Further Information Response

**Planning Permit Application No. TP-2019-979-1
300 City Road Southbank VIC 3006**

Figure 1 - Extract of architectural render

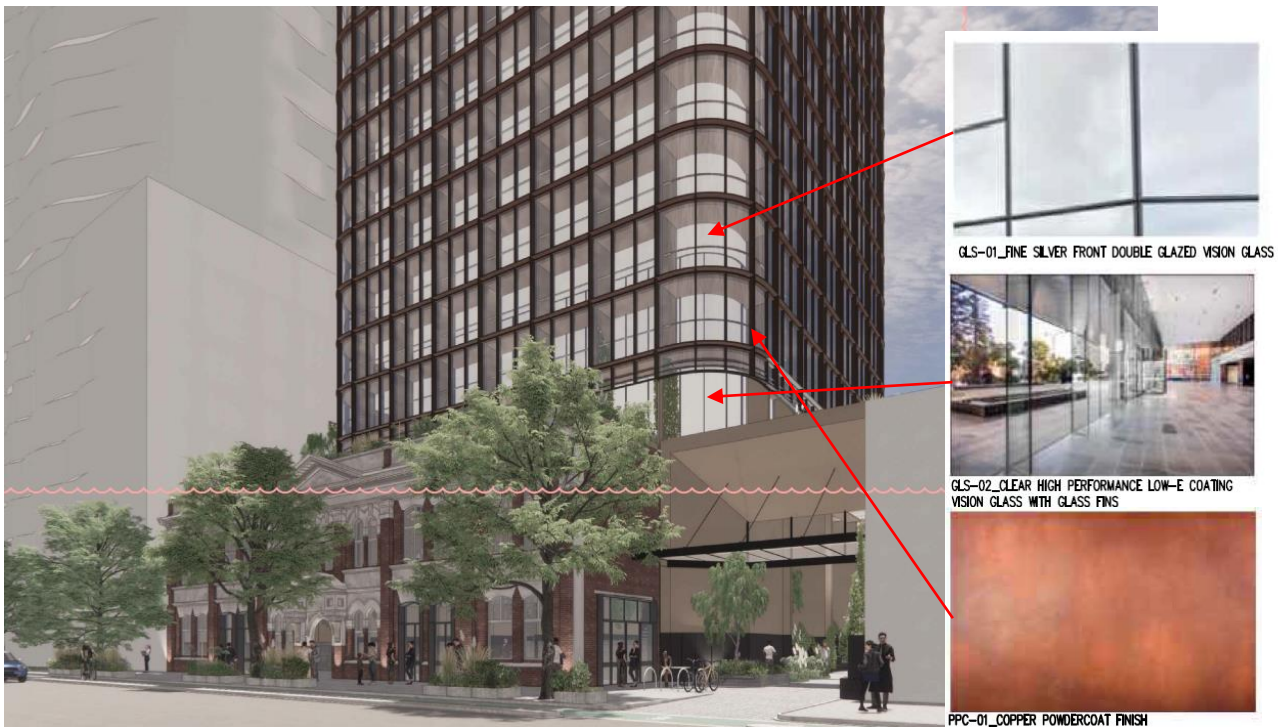
Concern has been raised in respect to the reduction in the extent of glazing between the heritage façade and tower form.

We note the clear glazing (vision glass) previously associated with Levels 2-7 was due to the non-residential / hotel / commercial uses that were previously approved within this space. These levels comprised of greater floor to ceiling levels and provided glazing to increase passive surveillance / activation of these non-residential areas.

Given this amendment seeks to introduce additional levels within this area which are primarily of a residential nature (reduced floor to ceiling levels etc), it would not be appropriate to apply clear glazing to these levels. Where non-residential uses are proposed (i.e. commercial offices on Level 1 and communal uses on Level 2), the clear glazing to the exterior façade has been retained.

The façade will remain appropriately articulated by way of the copper powder-coat finish framing elements. It is noted 'glazing' will still be utilised throughout the tower form (albeit not clear glazing), but rather fine silver front double-glazed vision glass will be utilised to ensure a high-level of internal amenity for the residential apartments.

It is submitted that the reduction in glazing above the heritage façade does not detract from the built-form, but rather continues to provide a harmonious and cohesive façade when viewed from the public realm.
